## SRFB Grant Regional Application Materials

<b>Submission Date</b>	2018-03-30 13:19:08
	Mill Creek Fish Passage Project
<b>Sponsor Organization</b>	Chelan County Natural Resource Department
<b>Sponsor Contact Person</b>	Mike Kane
<b>Sponsor Address</b>	411 Washington St
<b>City</b>	Wenatchee
<b>State</b>	WA
<b>Zip Code</b>	98801
<b>Phone Number</b>	509-885-2126
<b>E-Mail Address</b>	kanenaturalresources@gmail.com
<b>PRISM #</b>	181824
<b>Habitat Work Schedule #</b>	181824
<b>Anticipated Request- SRFB</b>	131476
<b>Anticipated Request- Tributary Committee</b>	0
<b>Total Anticipated Request (SRFB and Trib)</b>	131476
<b>Anticipated Other Funding</b>	494599
<b>Anticipated TOTAL Budget</b>	626075
<b>% of budget request from SRFB</b>	21
<b>In one or two sentences, what do you propose to do?</b>	The proposal will be for final design, permitting and construction of a fish passage barrier replacement on Mill Creek, a tributary to Peshasting Creek.
<b>What subbasin is the project in?</b>	Wenatchee

# Mill Creek Fish Passage Project

### SRFB Panel

Figure 5. 30 % plans

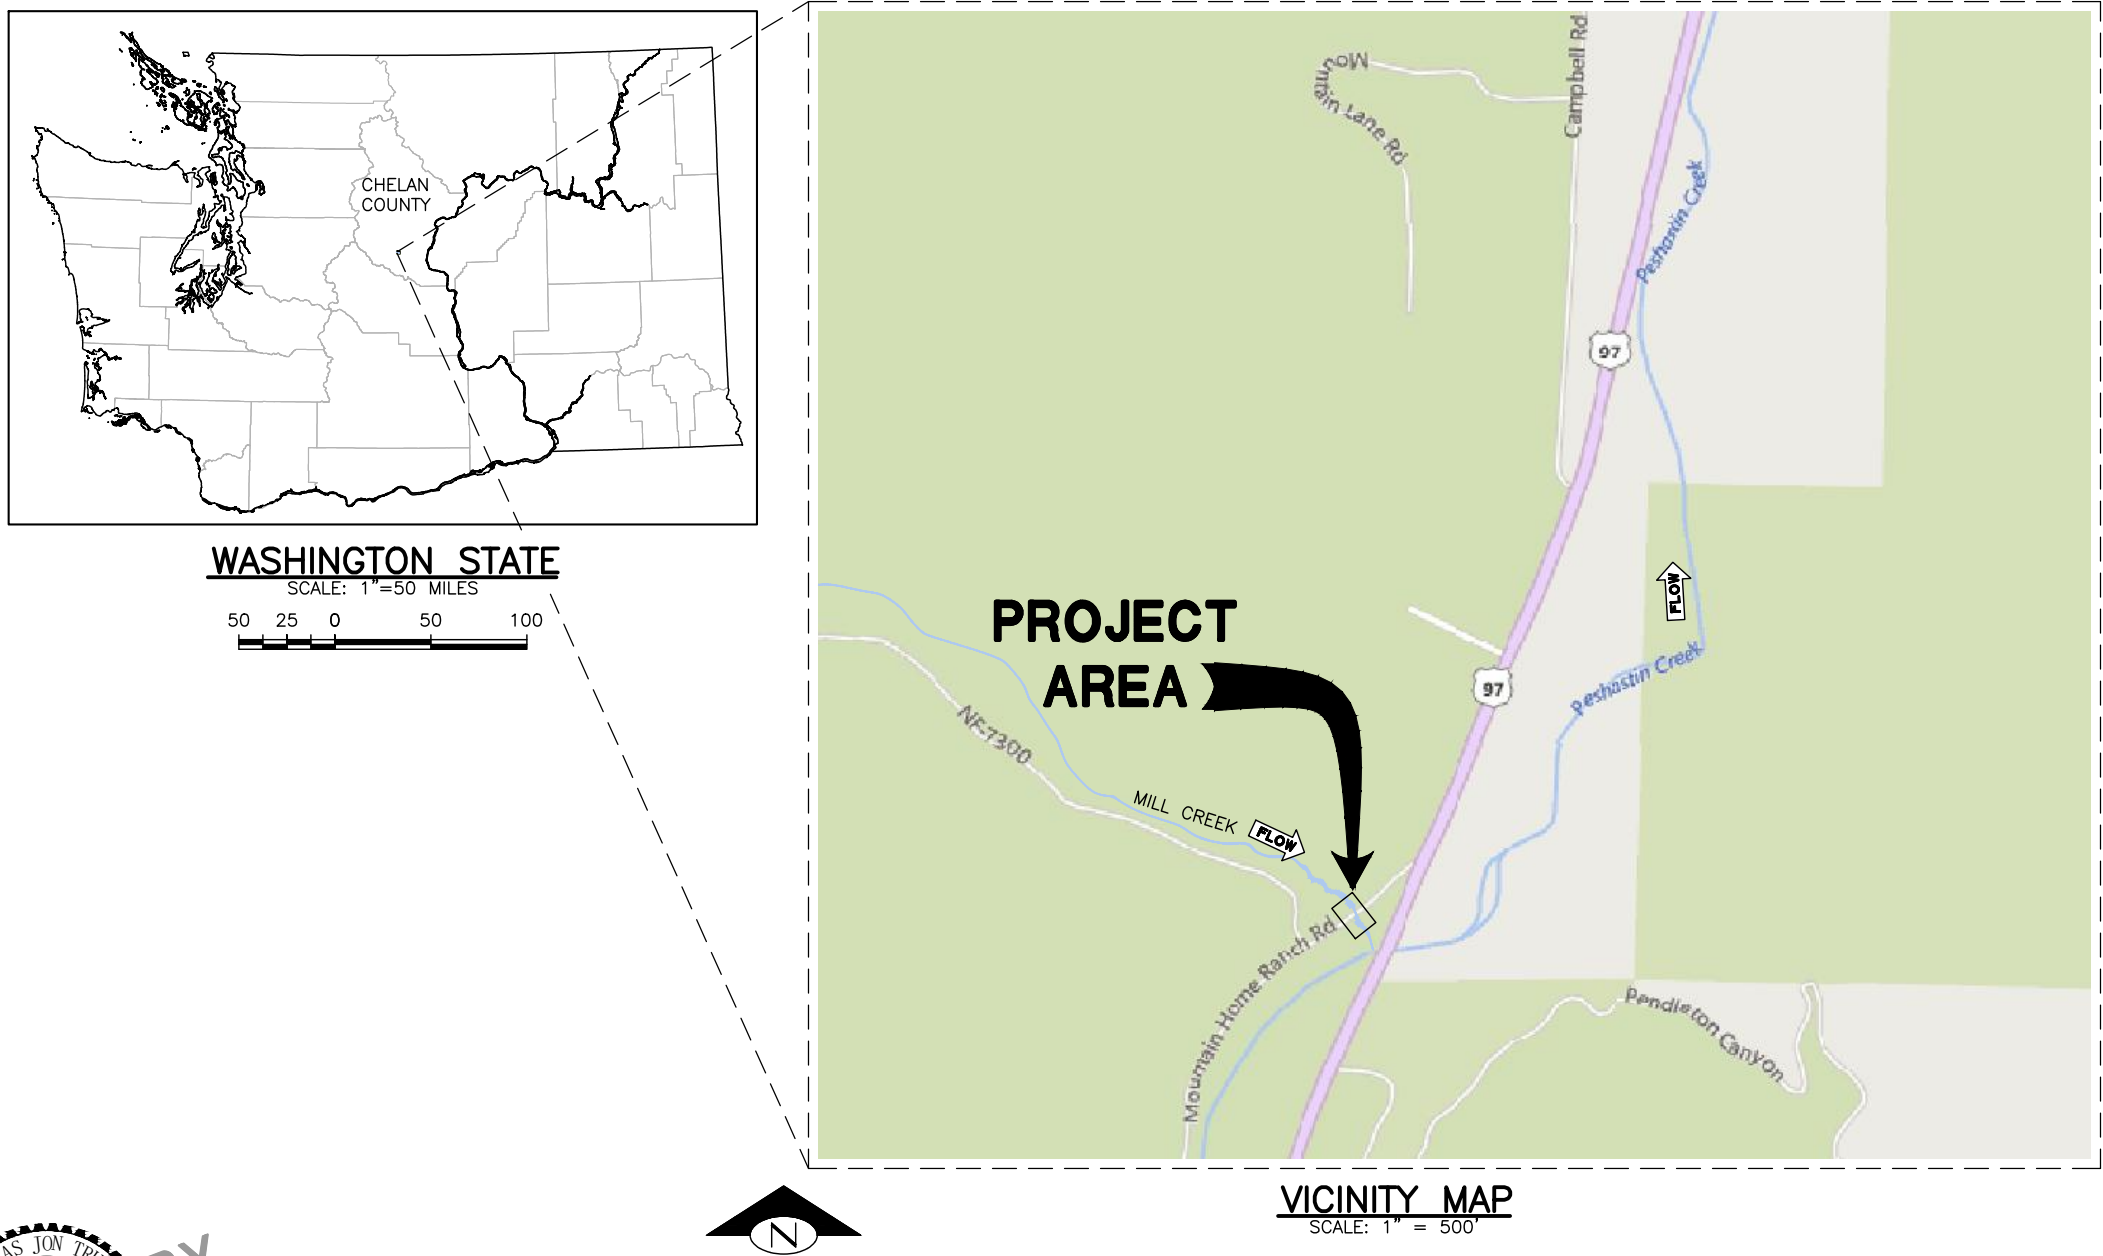
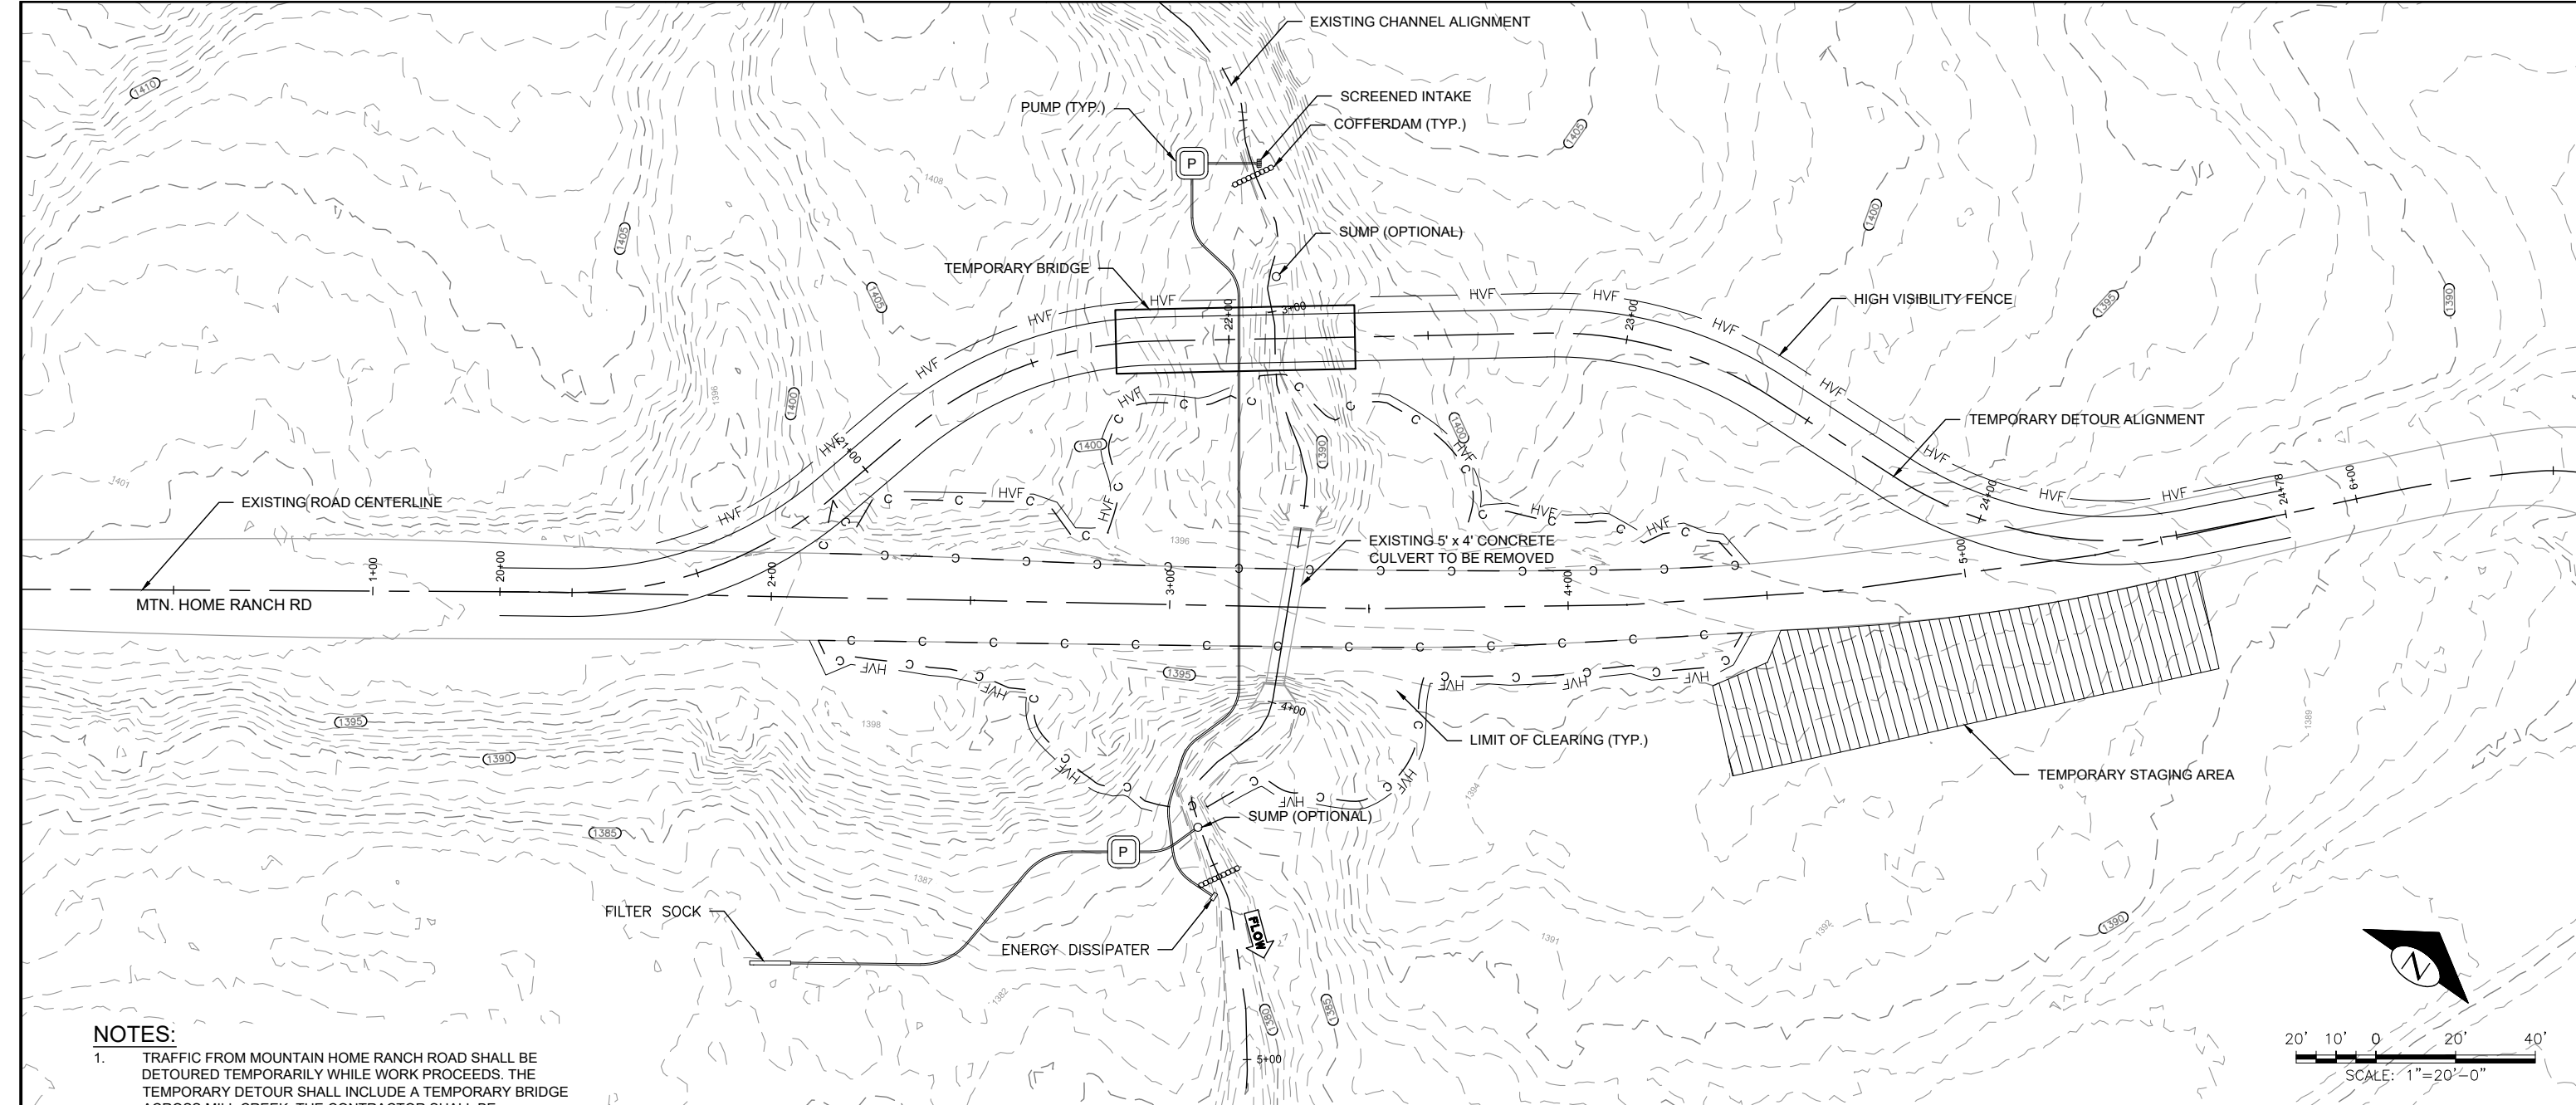
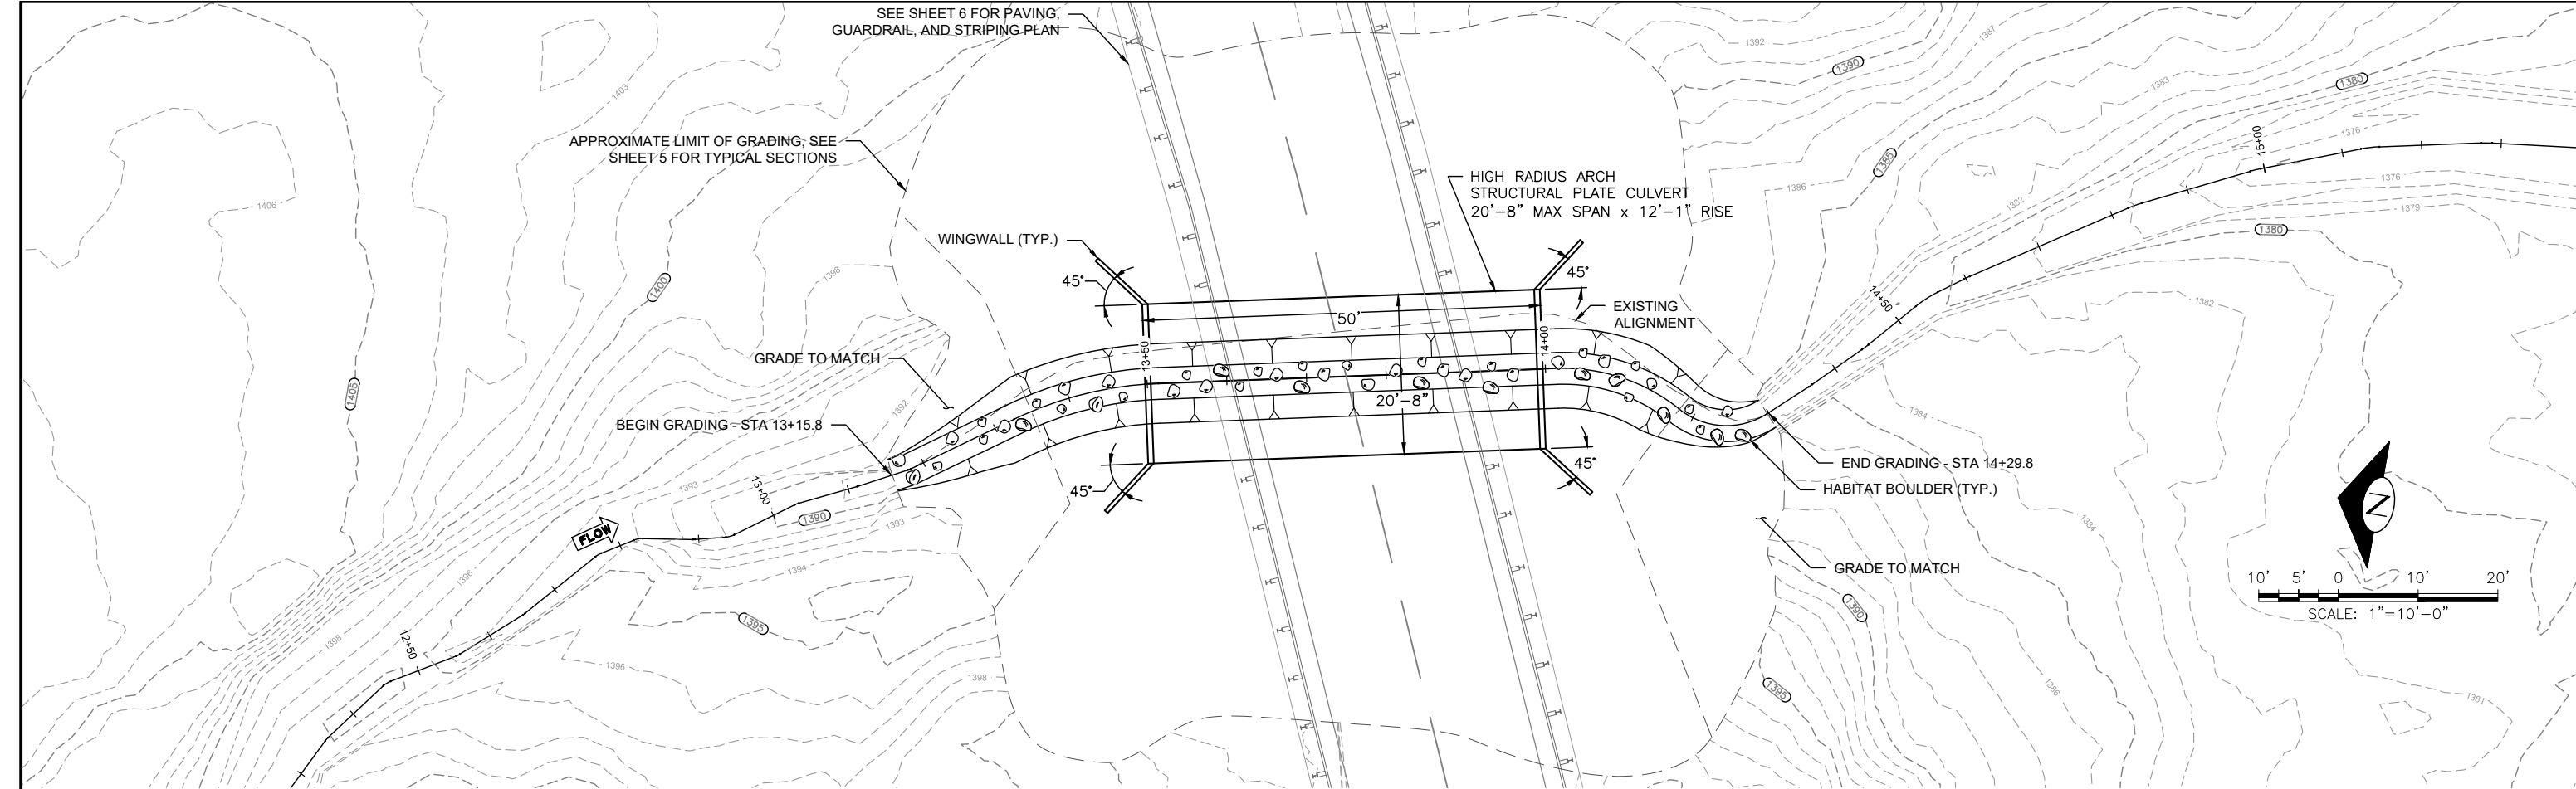
The proposal references "current 30% design"; please load this to PRISM. Preliminary designs and a basis of design (BOD) report that meet the criteria identified in Manual 18 Appendix D will need to be posted on PRISM before final application. The BOD report should include a discussion of the alternatives considered and the rationale for the preferred selection. If this will not be feasible, the grant should be for design and permits, without construction. The cost estimate shows nice detail on construction costs but should also include match and show the total project cost.

"Figure 5" of this document is the complete set of 30% design plans. 60% preliminary designs have not been completed. The design team has included total project cost and anticipated match from FBRB for this project, but does not have a completed basis of design report at this time and does not have current funding to complete prior to the final PRISM submittal. The sponsor has reduced the ask from SRFB to \$131,476 (21%).
